CHANGE ORDER NO 02R (#2009.182)

PROJECT: Jobs Peak Well No. 2 Replacement

To: Cathe Pool P.E.
From: Dale Bugenig
CC: Ray Kruth, Mark Hanneman
Date: June 20, 2009
Re: Job's Peak Well 2 Replacement – June 19, 2009 Pumping Test Results and Well Design Recommendations

Figure 1: Well 2R pumping test data.

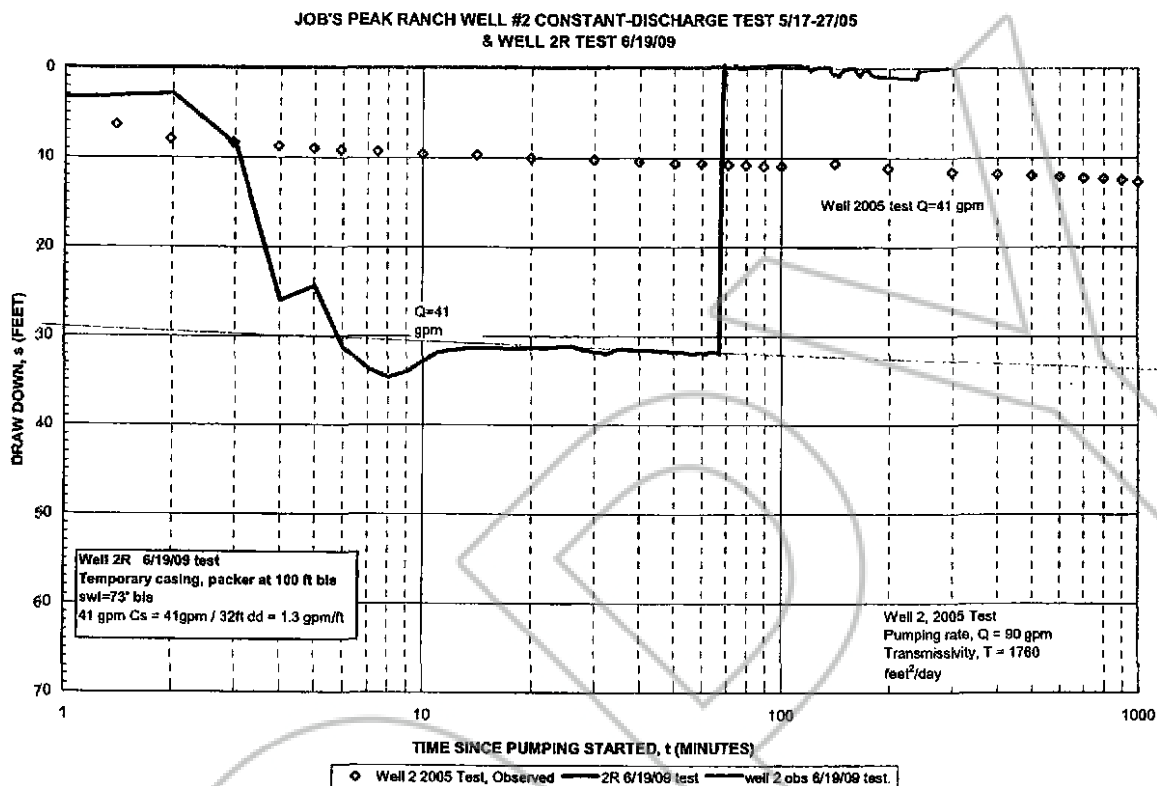
The drawdown and recovery data from the June 19th test are plotted in Figure 1, where they are compared with the drawdown from the 2005 test of Well 2. It is obvious from the test that the drawdown in Well 2R at a pumping rate of 41 gpm is significantly greater than the drawdown in Well 2 at a pumping rate of 90 gpm, which translates to an approximately 40% decrease in effective aquifer transmissivity compared to Well 2, based on transmissivity calculated from early-time drawdown data. These results appear to confirm the results of analysis of previous test pumping and a fluid-entry survey that suggested a significant portion of the groundwater pumped from Well 2 originated at relatively shallow depths. As a result, it is our opinion the replacement well may be expected to yield approximately 90 to 100 gpm.

Figure 2: Well 2R sieve analysis.

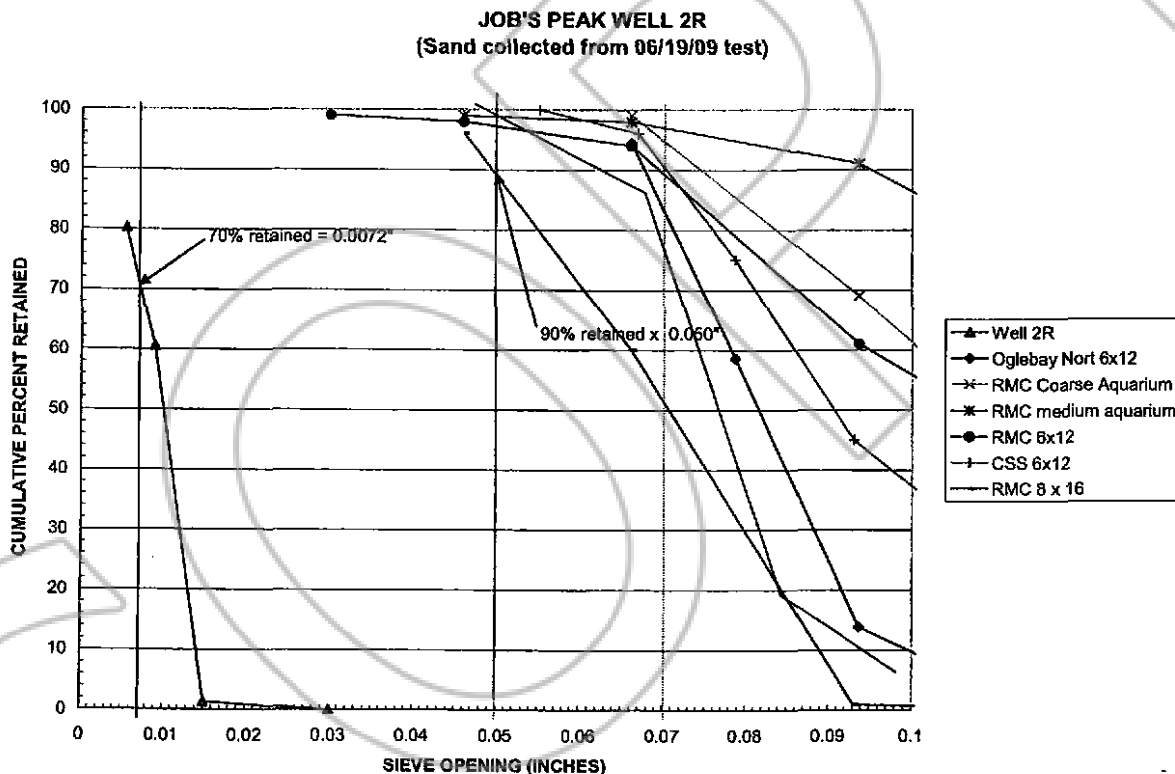
As you are aware, the discharge from the well during the June 19th test contained a large amount of fine sand, which is derived from highly-weathered granitic rocks. We performed an analysis of the sand, which yielded a D_{70} retained of 0.0072 inches. The results are shown in Figure 2.

On the basis of the sieve analysis, we have revised our initial recommendation for filter pack and screen aperture width. Our current recommendation is RMC 8 x 12 mesh filter pack or equivalent, which is compatible with 0.050-inch slot aperture width screen.
